**Supplemental
Notice of Allowability**

10/725,521

SHIRIE, NOBUYUKI

FIG. 6

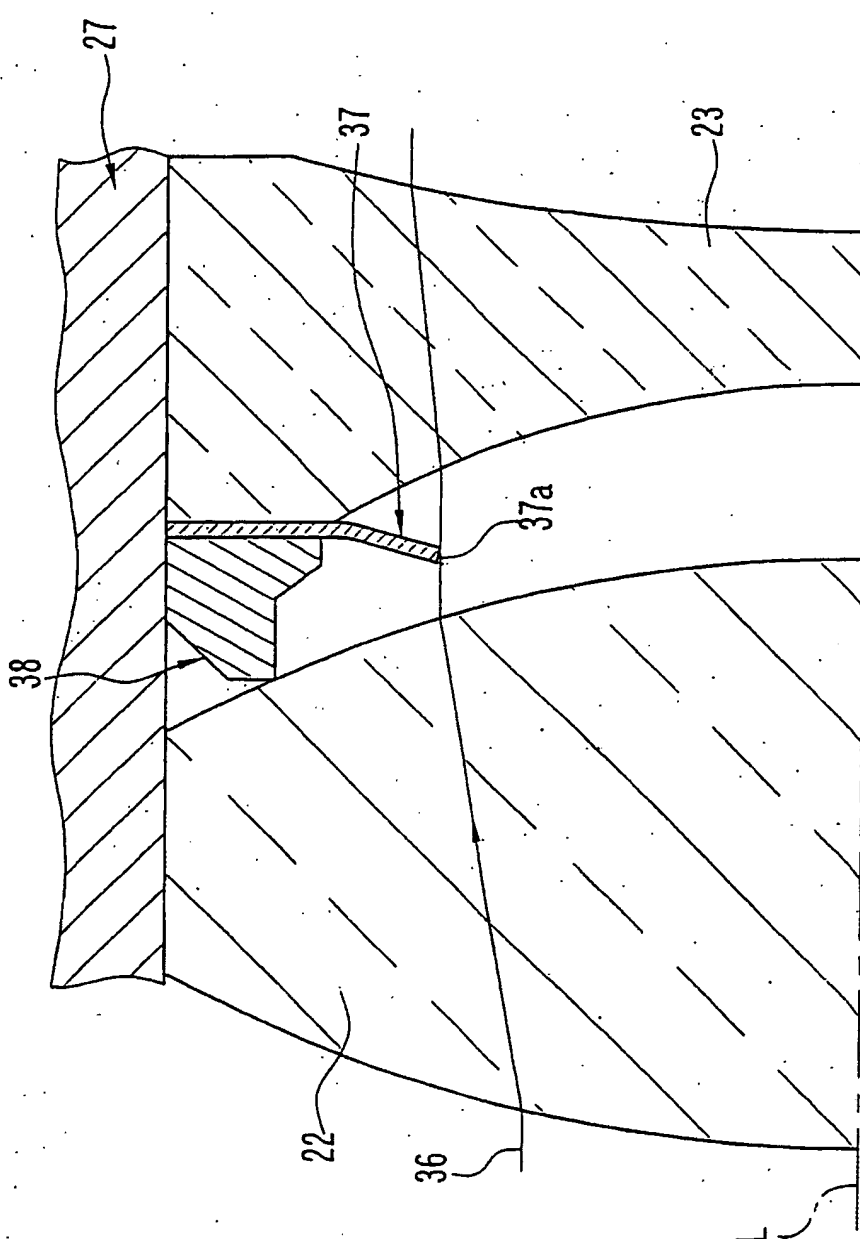
2. The drawings contained two replacement sheets of figures 6 and 7 were received on 10/20/06. These drawings are approved by the Examiner. Applicant should note that the drawings now contain figures 1, 2, 4, and 5 filed on 12/3/03; figure 3 filed on 11/25/05 and figures 6 and 7 filed on 10/20/06.
